STAFF REPORT SUMMARY

To: Edgerton Planning Commission
Fr: Kenneth Cook, AICP, CFM, Community Development Director
Re: PS2017-02, Preliminary Site Plan for LPKC Lot 3 – Inland Port VI, located on the South side of 183rd Street and East of Montrose.

STAFF REPORT

To: Edgerton Planning Commission
Fr: Kenneth Cook, AICP, CFM, Community Development Director
Re: Application PS-2017-02 for Preliminary Site Plan for Logistics Park Kansas City, Inland Port VI, located at the southeast corner of 183rd Street and Montrose Road.

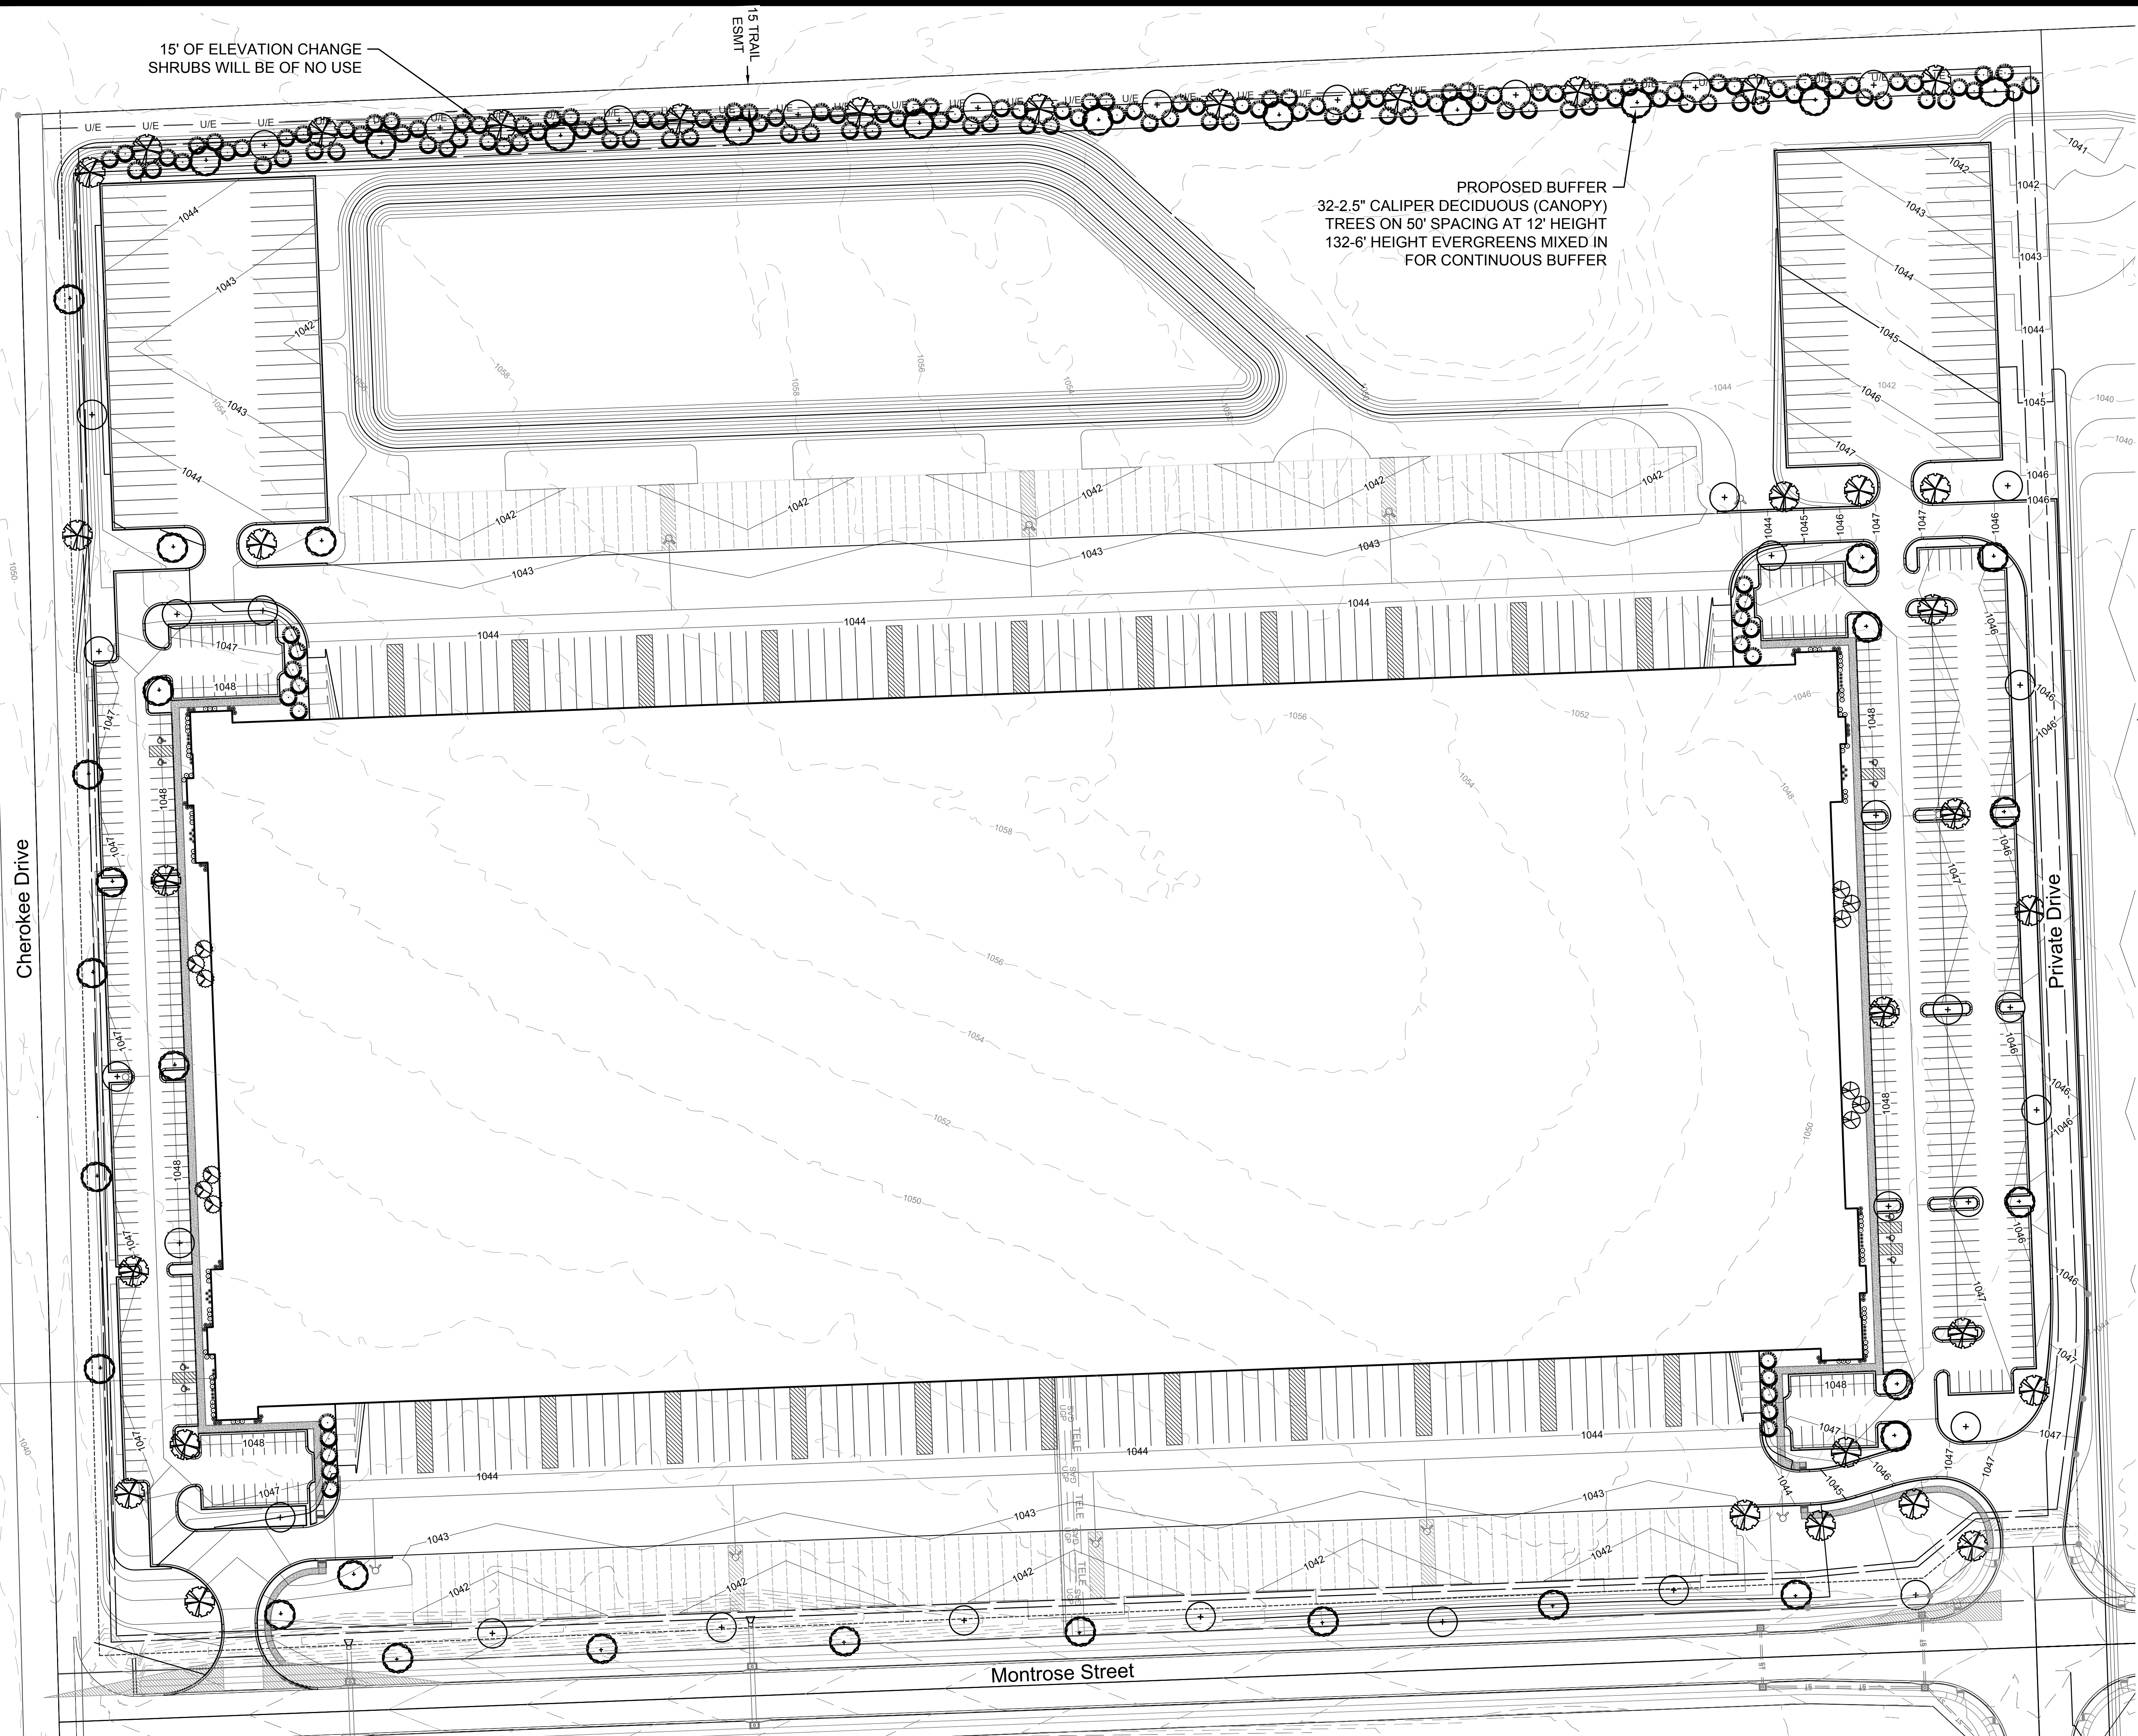
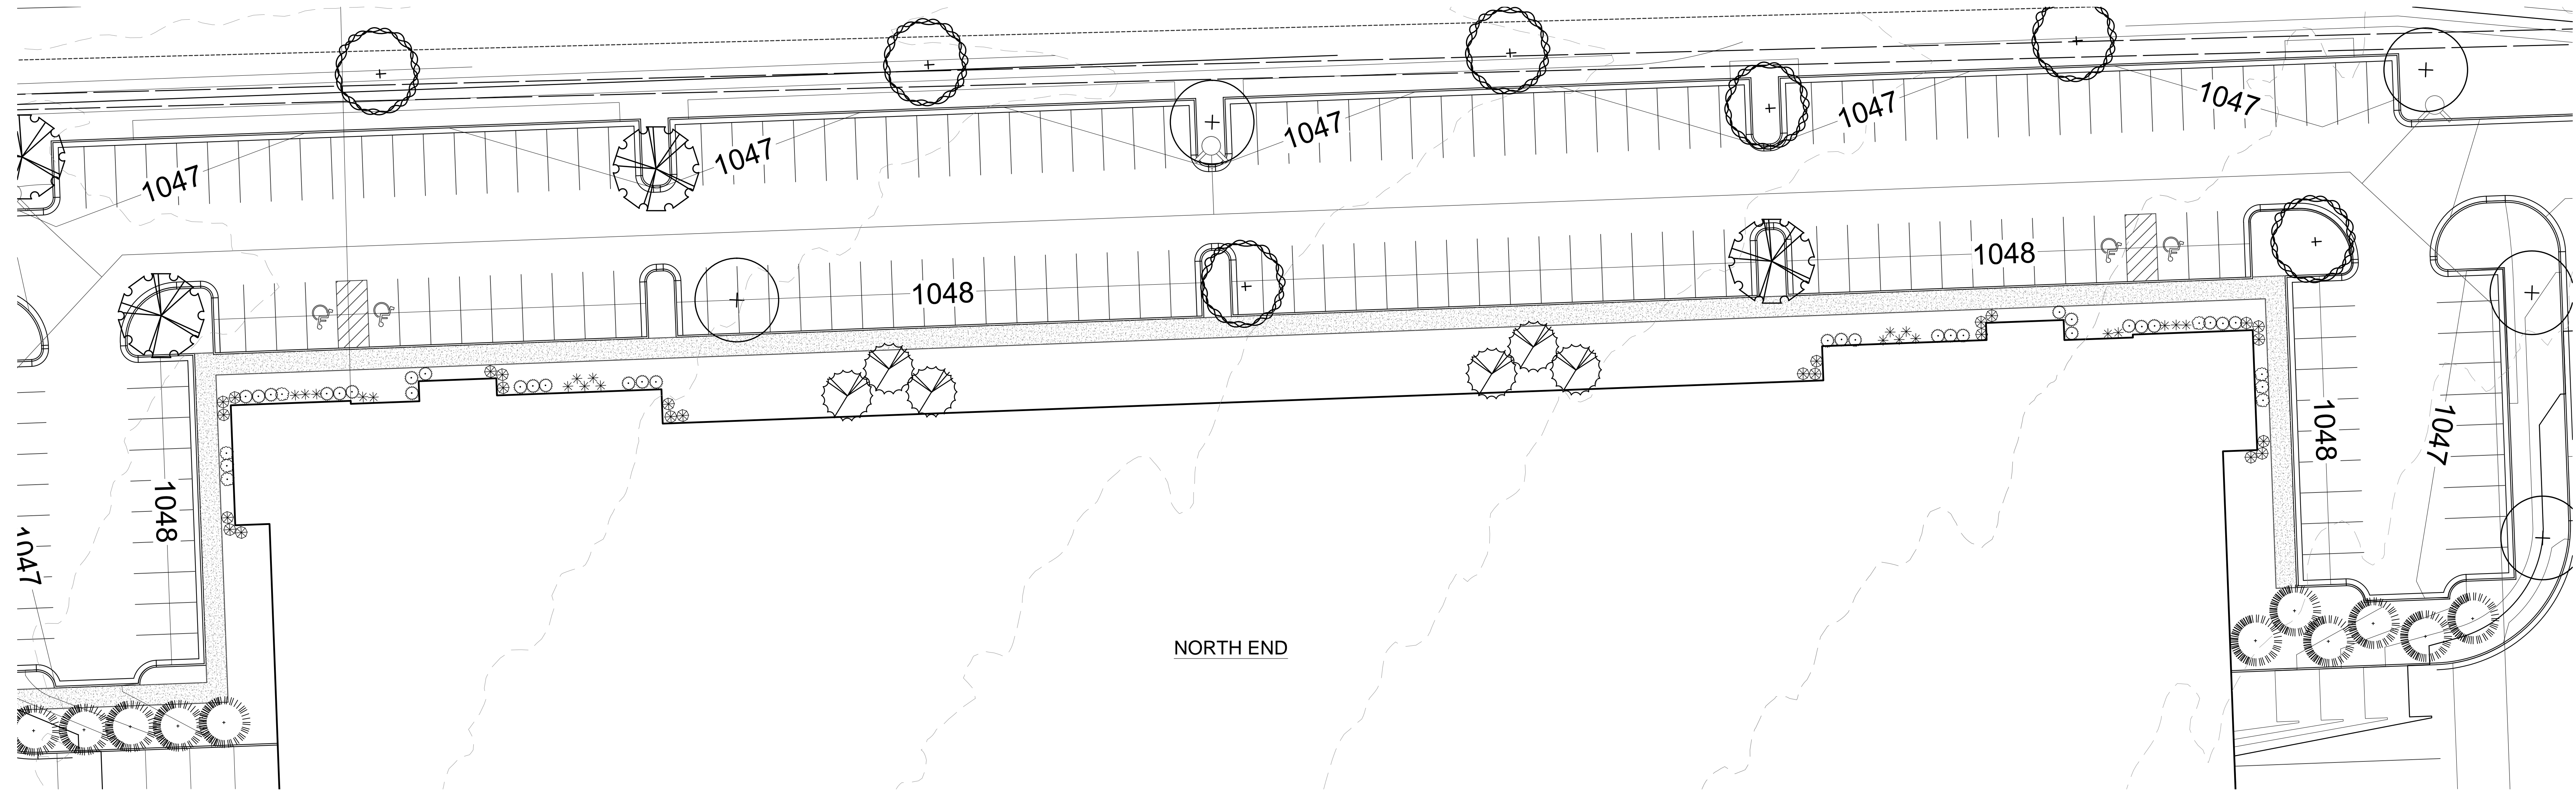
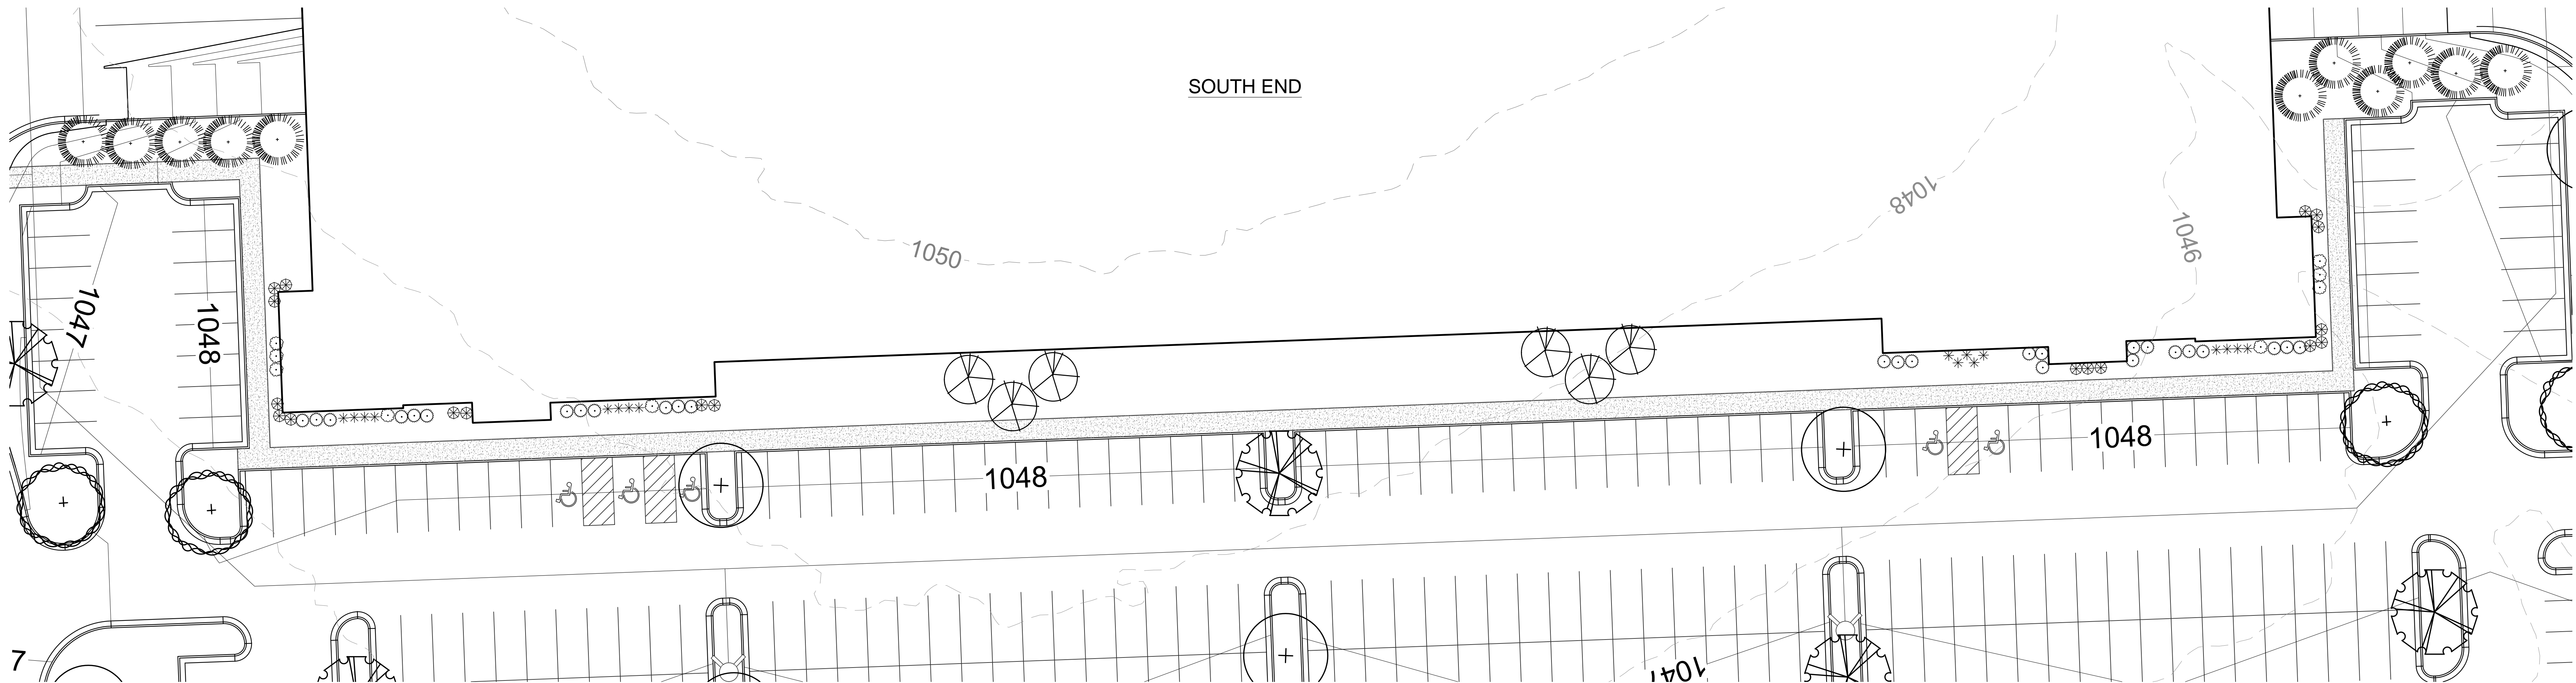
2. Sheet #2
 - a) A landscape plan drawn to scale, showing the site, building location, planting and seeding schedules, refuse and outdoor storage screening and boundary screening. All landscape features shall be shown in relation to sidewalks, paths, lawns, parking areas and drives. ***Landscape plan will need updating. Screening of trash enclosures should be shown. A Landscape plan has been submitted.***

1. Right-of-way Buffer Width Requirements. *ROW buffers are required to be placed along Montrose Street and that portion of 183rd Street with views of the trailer storage area. City regulations specify these buffers require 1 tree per 50 LF of ROW within a 10 foot buffer width. The ROW buffer shown along Montrose Streets shows trees at 1 per 100 feet. That portion of 183rd Street with view of the trailer storage area should have the same buffer. Trees along 183rd are spaced at approximately 1 every 90 feet. The screening should be varied more, clusters of trees are "encouraged to create a more natural appearing environment" (Section 5.2.O.4) and the use of berms or other elements can also assist in making a design less monotonous. ROW buffers also require the placement of shrubs at a maximum spacing at 48 inches with a minimum of 25% located within the buffer area. **The landscape plan needs to be adjusted.***

- a. *The type 1 buffer requires a 5 foot buffer width and trees at 50' spacing (all within the 5 foot buffer) and hedge/shrub at 48" spacing (with 25% within the 5' buffer). Evergreen trees (Keteleeri Juniper) shall be a minimum 12' height. Deciduous trees shall be a minimum 2.5" caliper. Hedge/shrub shall be a minimum 24" high. No shrubs are currently shown in this buffer.*

- b. *The type 4 buffer requires a 20 foot buffer width and trees at 50 foot spacing (all within the 20 foot buffer) and hedge/shrub at 48 inch spacing (with 100% within the buffer). Evergreen trees (Keteleeri Juniper) shall be a minimum 12' height. Deciduous trees shall be a minimum 2.5" caliper. Hedge/shrub shall be a minimum 24" high. The spacing of deciduous trees is currently shown as 50' with additional Junipers (6-foot height) placed in between. Approximately 4-5 Junipers are placed in between the deciduous trees which calculates to a spacing of approximately 10-12.5 feet on center while the table specifies a spacing of 3 feet on center. A note is included on the plan stating "15' of elevation change-shrubs will be of no use". Staff would still suggest that groupings of shrubs should be placed at intervals along this area in order to provide additional variation of the buffer.*

The Landscape Plan needs to be adjusted.
3. Buffer Composition Requirements. *Deciduous trees shall be a minimum 2.5" caliper. Evergreen trees shall be a minimum 12' height. Bushes shall be a minimum 24" high. All plant material need to comply with these minimum requirements. As such, the Landscape Plan needs to be adjusted.*

4. Screening from Residential Uses. *Lot 3 abuts single-family residential uses along its eastern property line that also serves as the corporate city limits with Gardner, Kansas. City regulations specify a Type 4 buffer will be required. This area is identified in the 2013 Southwest Johnson County Area plan accommodating a trail as specified by and depicted in the Active Transportation Network System Map.*

5. Dumpster screening. *Trash enclosures or screening are not shown. Plans shall be updated to satisfy the dumpster screening requirements in Article 5.2 K 8.*
